Docket Item # 17
BAR CASE # 2017-0200

BAR Meeting
July 5, 2017

ISSUE: Certificate of Appropriateness for Alterations

LOCATION: 210 Jefferson Street

210 JEFFERSON STREET
FRONT ELEVATION - PROPOSED
 $\frac{1}{4}'' = 1'-0''$

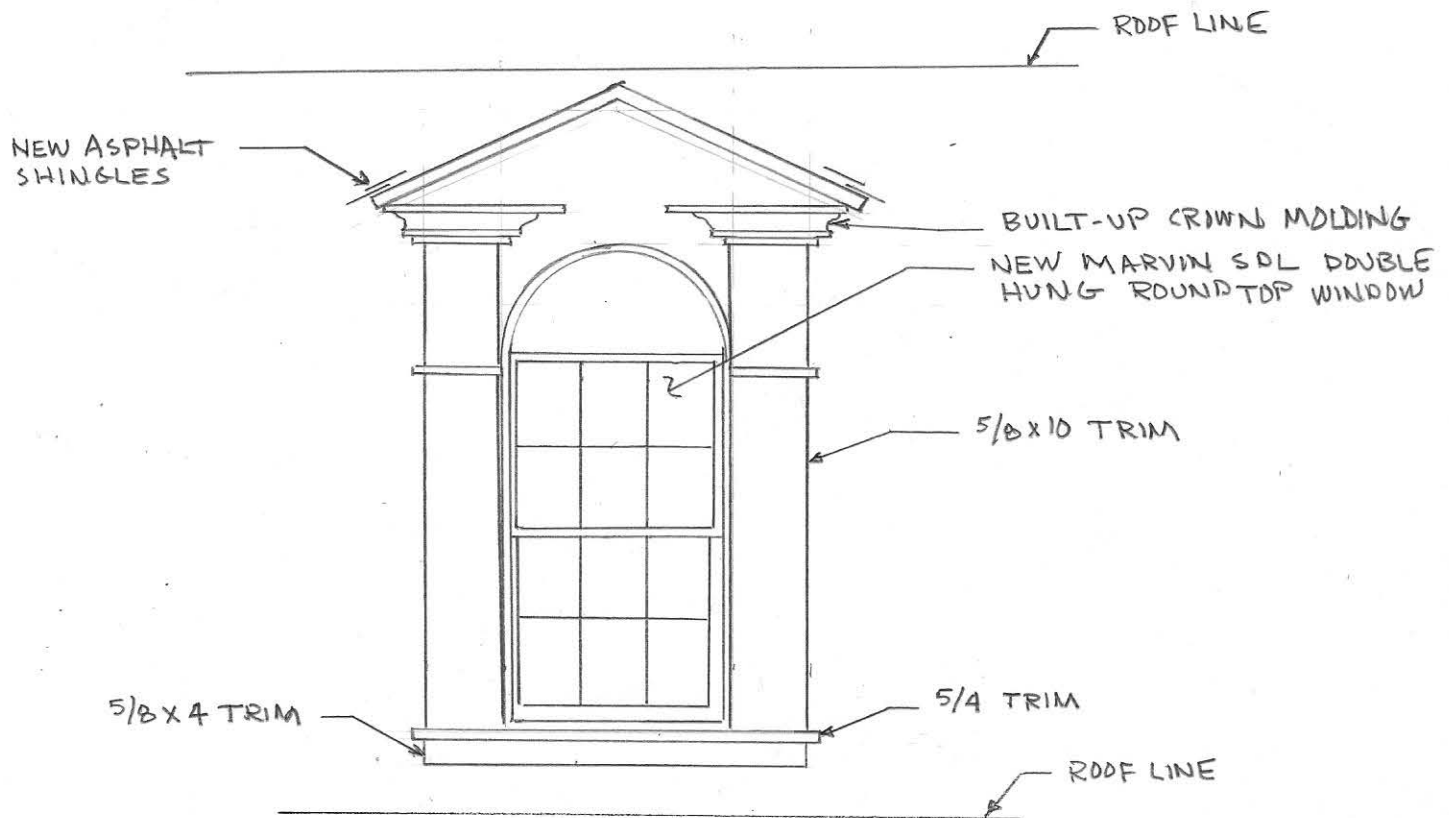
The applicant also proposes to replace the four windows on the front, and add pilasters and crown molding to the existing two front-gable dormers. The replacement windows at the dormer are proposed to be arched top double-hung windows with a light configuration, inspired by Georgian style dormers on Gentry Row on Prince Street. Staff concurs that the existing dormers are poorly proportioned, could use improvement and has no objection to the more classically inspired design. However, the proposed alterations require reconstruction of the dormer roof and the enlarged dormers will have to be even taller to contain the new windows and trim, at the risk of overwhelming the two-story dwelling below. In addition, staff notes that the dormer window materials in the application package are inconsistent. The drawings show a 6/6 sash with a single light transom and the window specifications call for 1/1 with a round-top upper sash. Finally, while the proposed dormer trim was used during the Colonial Revival period, it is much more grand than was used on the simple townhouses in the Yates Garden development. It is also not the same proportions as the applicant's example and is incomplete, lacking the molding in the rake below the apex of the pediment.

Should the BAR find the arched window and revised dormers to be appropriate for this house, staff will continue to work with the applicant and the window manufacturer on a round top double hung sash without a transom and with an appropriate divided light design and surrounding trim.

The 1st and 2nd story windows on the front (north) elevation are shown to be replaced appropriately in-kind with painted wood SDL windows with composite trim proposed around each opening. Trim such as this is used on wood frame houses to receive the siding at the jamb, not applied to the face of masonry structures. Indeed, the window trim example in the application is surrounded by clapboard siding. Masonry buildings have brick mould trim that is recessed from the face of the structure. Staff cannot support the proposed trim around these four windows.

1. Delete the decorative face trim at the four replacement windows on the first and second floor;
2. Work with staff on the proportions of the entry door surround;
3. Work with staff on final design details of the pedimented dormers to improve the proportions and make the stylistic elements compatible with the vernacular townhouse;
4. The existing round wood window adjacent to the front door must be carefully removed and stored on site for possible future reuse; and
5. All replacement windows must meet the Alexandria Replacement Window Performance Specifications.

DOOR ELEVATION

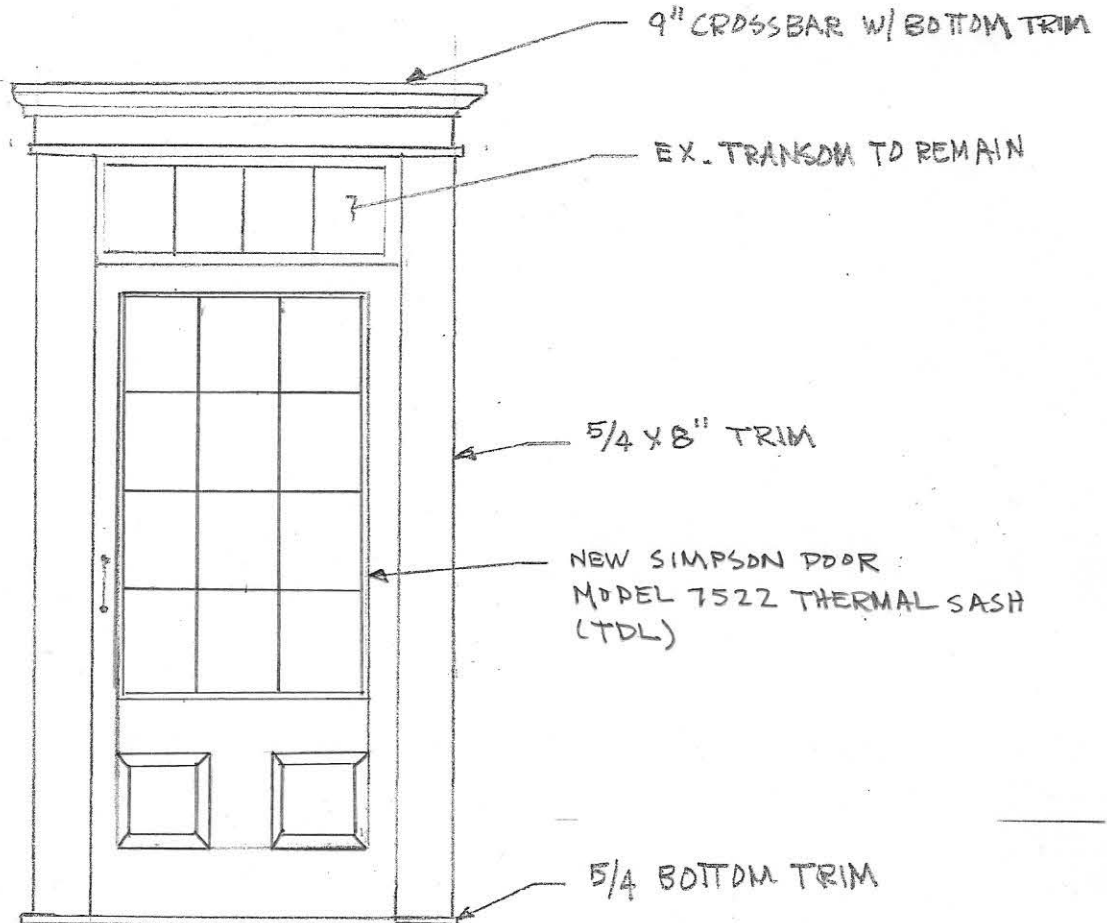
An accentuated front door is an important identifying feature of the Colonial Revival style. Entrance doors in this style often had large glazed areas and the proposed 12 light wood door design is architecturally appropriate. Boral brand synthetic wood trim will surround the

proposed door, and the simple trabeated (post and beam) forms are generally consistent with the door. However, the proportions of the trim surrounding the door need further refinement, as the trim on the sides should be significantly narrower than the entablature above the door is tall, or the entablature should be taller. While the BAR's Minor Architectural Elements policy only permits synthetic trim on buildings constructed after 1975, when these products generally became commercially available, staff supports its use in the proposed locations on this Yates Garden townhouse. Staff can work with the applicant on these details with direction provided by the BAR.
